Landscape Referral Response

Application Number:	DA2022/2081
Date:	28/09/2023
Proposed Development:	Change of use and construction of a golf club house and associated facilities
Responsible Officer:	Maxwell Duncan
Land to be developed (Address):	Lot 2742 DP 752038 , 292 Condamine Street NORTH MANLY NSW 2100 Lot 2742 DP 752038 , 292 Condamine Street NORTH MANLY NSW 2100

Amended Plans Comment 13/09/2023

Fig. 1 - Retention of trees 62-69 (centre of photo) would still allow for truck egress.

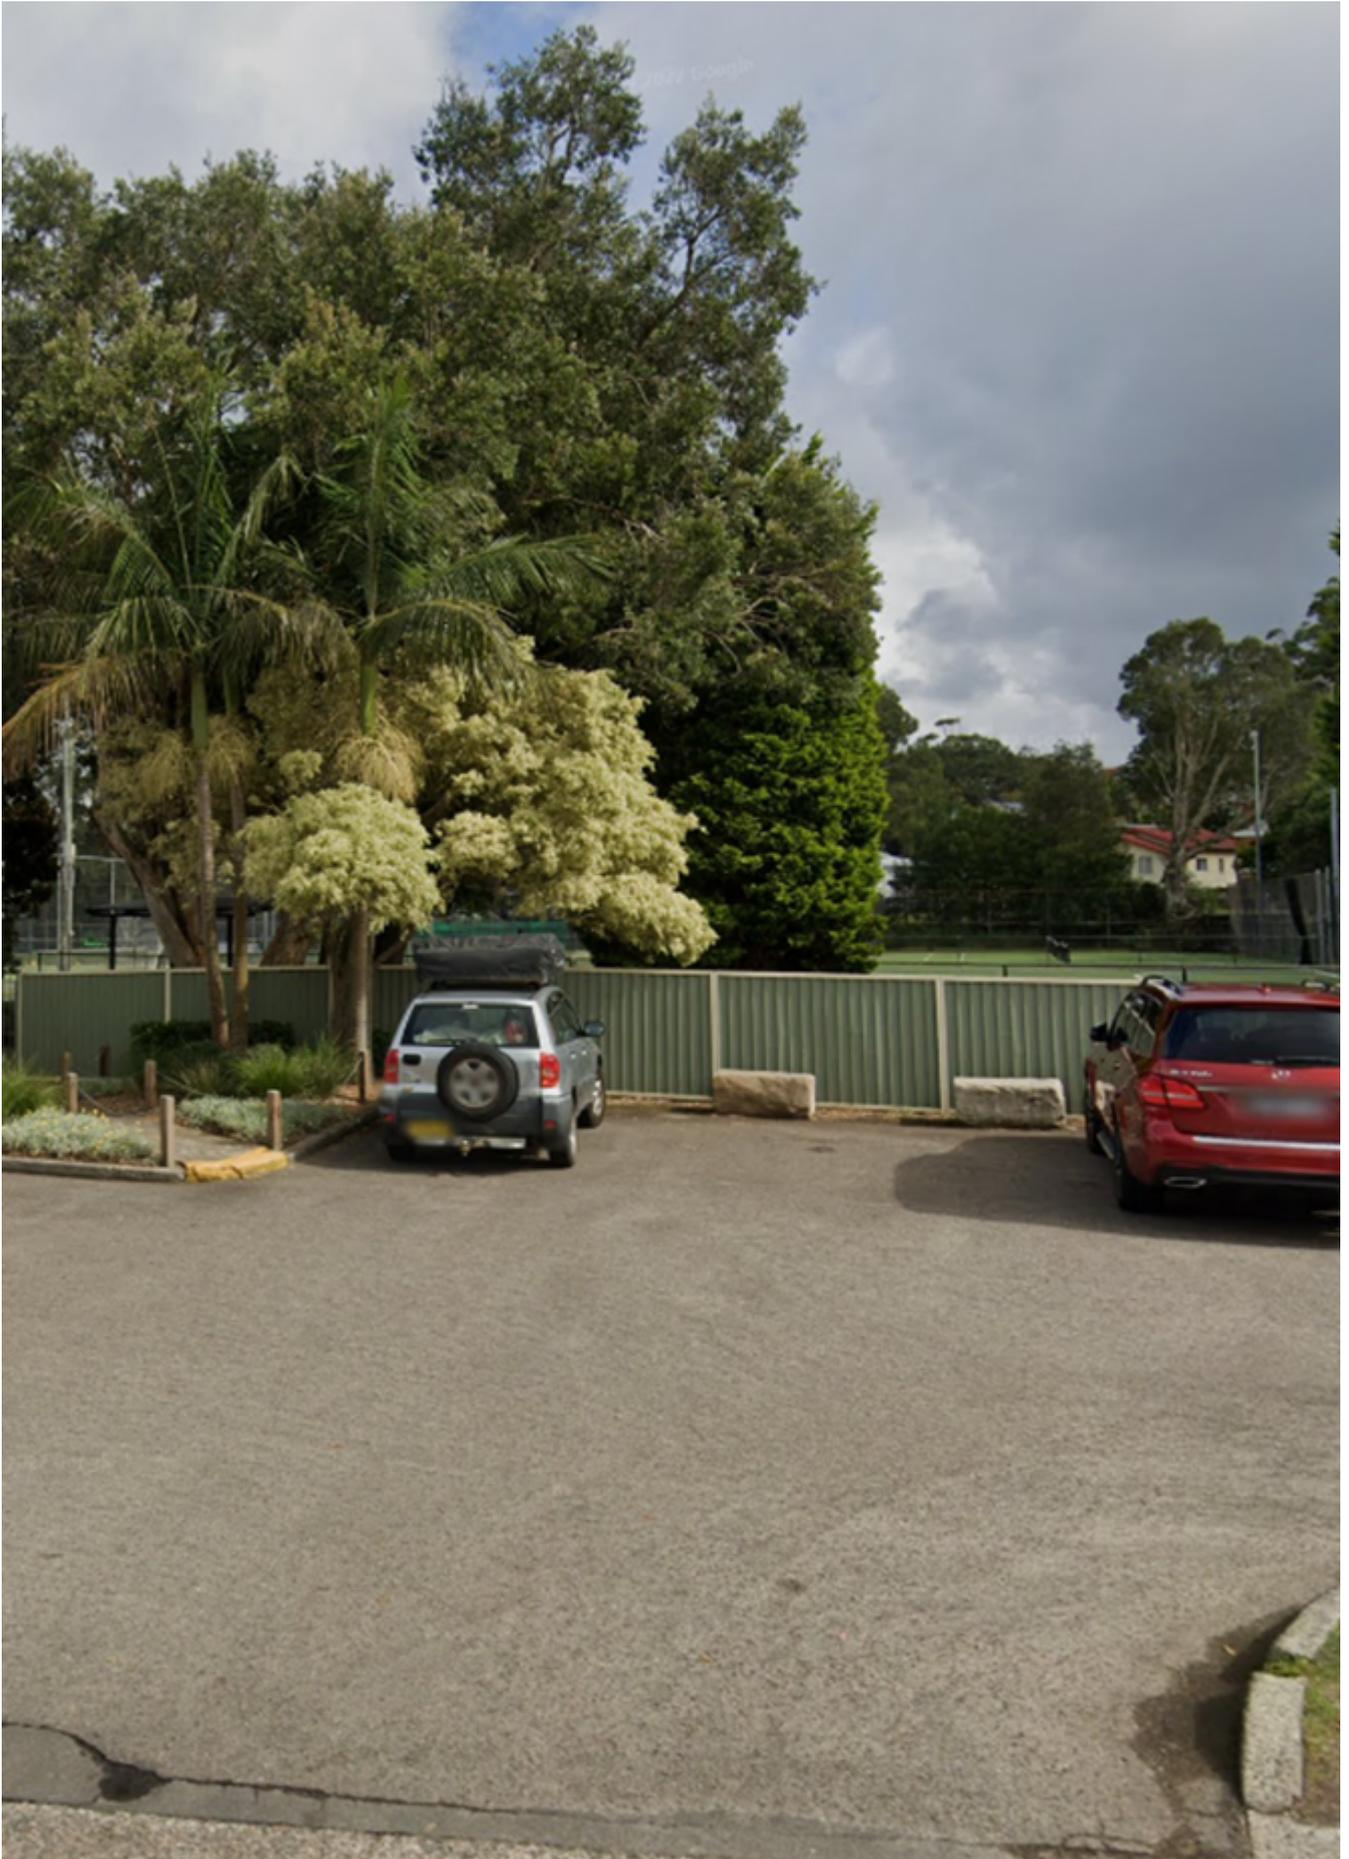
Of particular note is the proposed removal of 8 trees adjacent to the existing building (which is to be retained at this stage of works) as identified in the Construction Management Plan. It is apparent that Trees 62-69 can be kept for this stage of works. The existing driveways are to be used for truck movements and there appears to be sufficient room to enable the truck egress without removal of the trees. (Fig. 1 below).

Given the number of trees to be removed to accommodate the new clubhouse, retention of trees that aren't required to be removed for this stage of works would be beneficial in terms of environmental considerations and public relations pending future stages of works. Consequently, it is recommended

that Trees 1-3 and 62-69 should be retained.

Fig. 1 - Tree location plan from the Arborist's Report

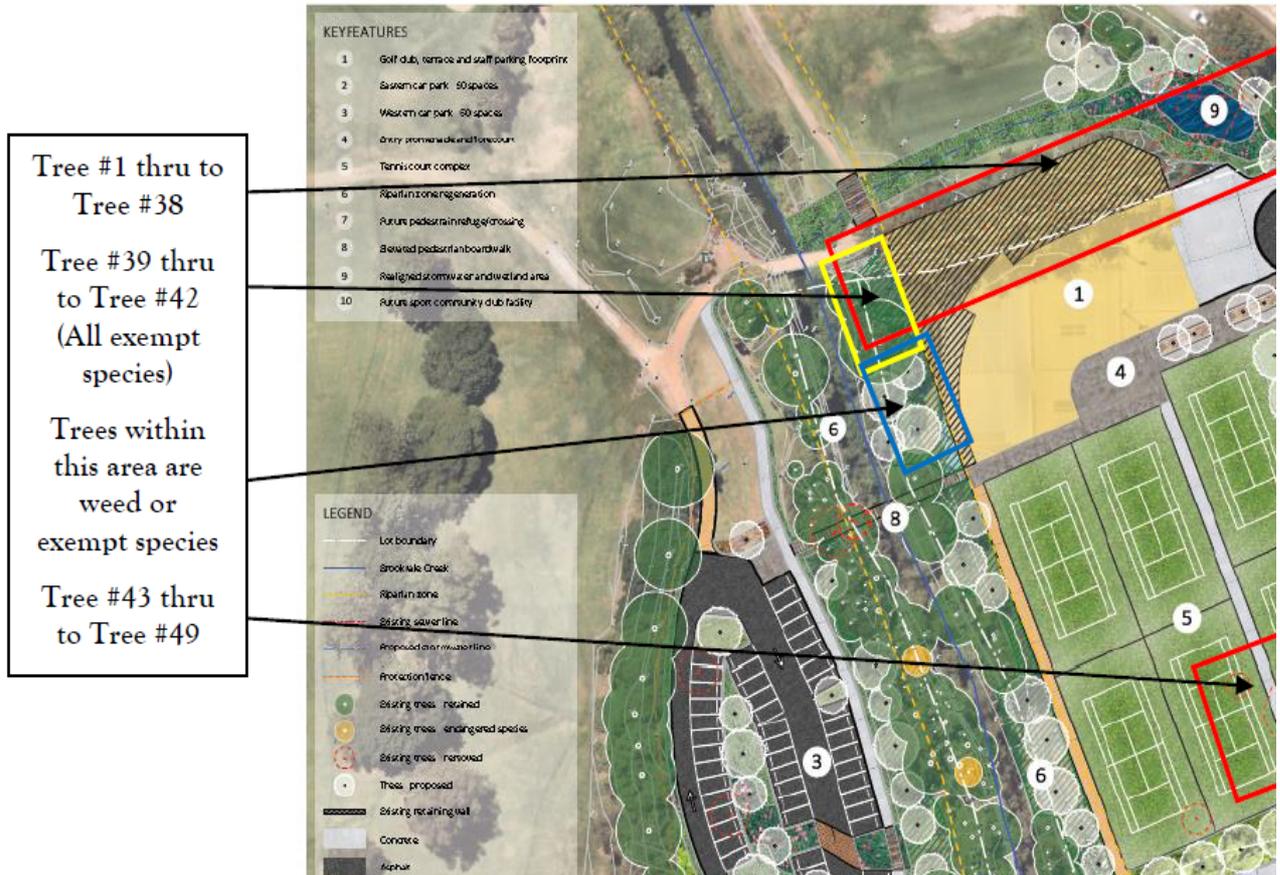
The Arborist's Report locates the trees on a plan in general location rather than identifying each tree. (Fig. 1 below)

The trees should be identified on the Survey Plan so that each tree is identified via their corresponding number in the Report. The trees' Tree Protection Zones and Structural Root Zones are also required to be shown on the plan to enable assessment of impacts of the proposed works and to clearly identify the trees to be removed and trees to be retained as applies to this application.

Fig. 2 - Surveyed tree location indicated on the Demolition Plan.

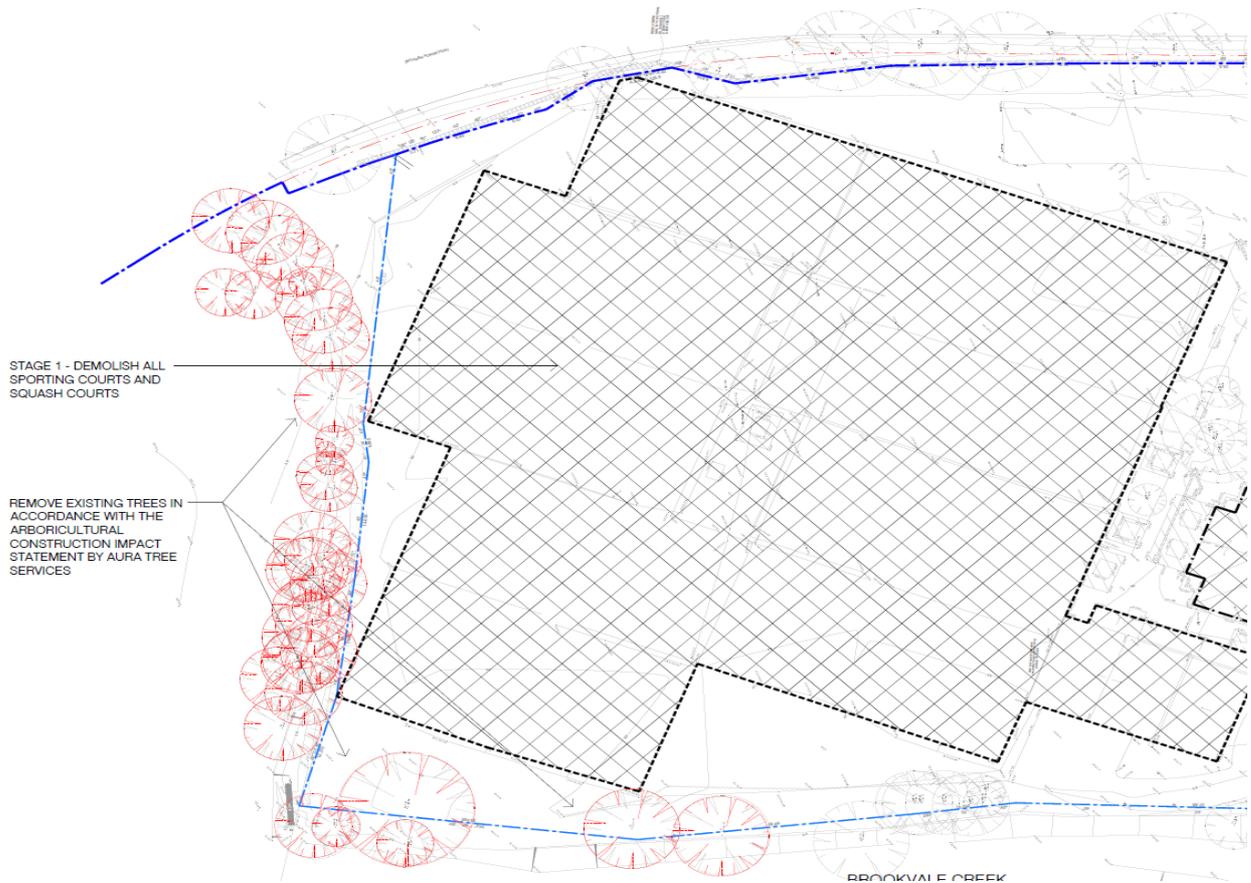
The Demolition Plan shows trees to be removed from a detailed a Survey Plan. (Fig. 2 below)

The Arborist's report appears to refer to trees being removed adjacent to the existing tennis courts whereas the Demolition Plan does not identify these trees to be removed.
